ACCESS REPORT

DEVELOPMENT APPLICATION

CONGO & SAVANNAH REDEVELOPMENT TARONGA ZOO

22ND MAY 2017

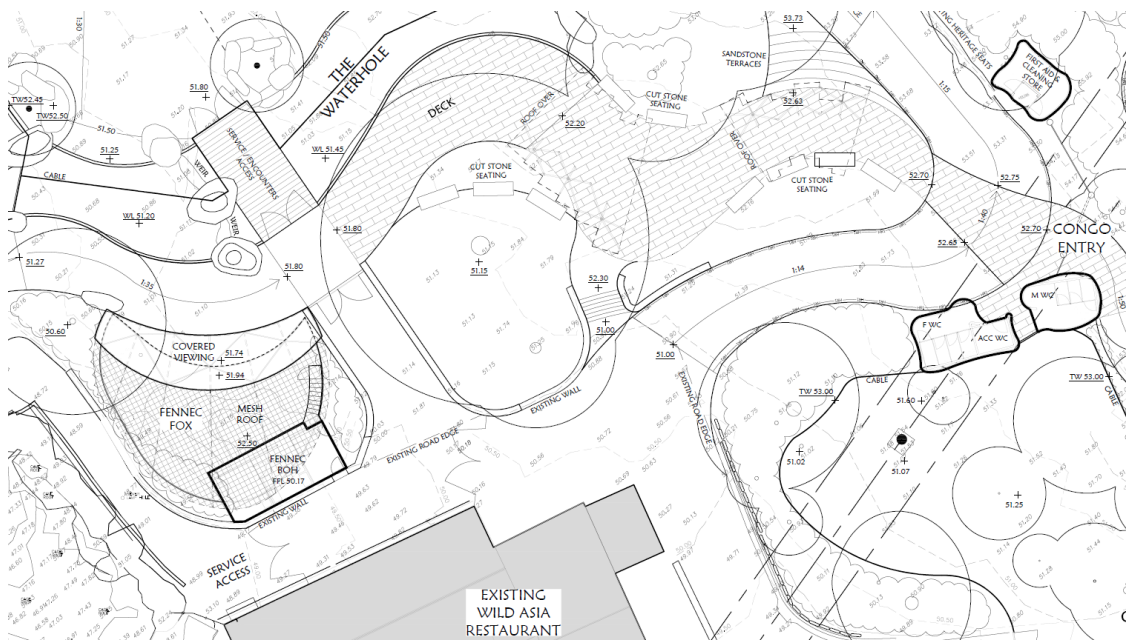
12. The 1:20 gradient walkway continues through the main viewing area to the no 2 Lions area and a medium sized viewing deck RL49.50 followed by a more gradual 1:40 slope to a second viewing deck RL49.25.

13. The existing path shall be upgraded to provide an even surface in concrete material that will comply with ASI428.1 while several elevated deck areas will also be constructed providing a flush transition to adjacent concrete pathways. The elevated boardwalk section shall provide shall also be upgraded consistent with ASI428.1 requirements.

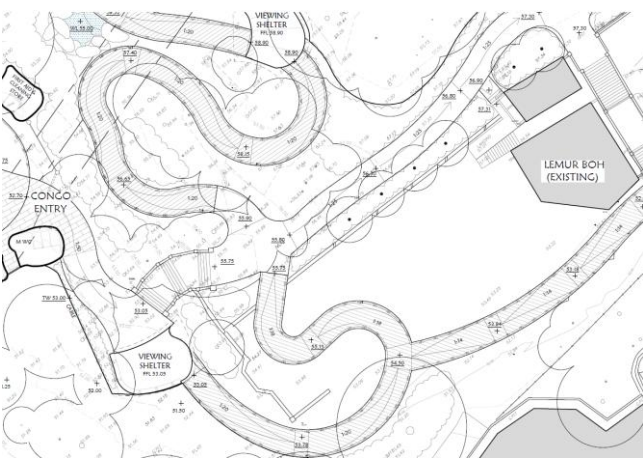
14. The balustrading along the 1:20 sections and elevated decks and walkways will be detailed in accordance with ASI428.1 to satisfy the BCA and DDA Premises Standards.
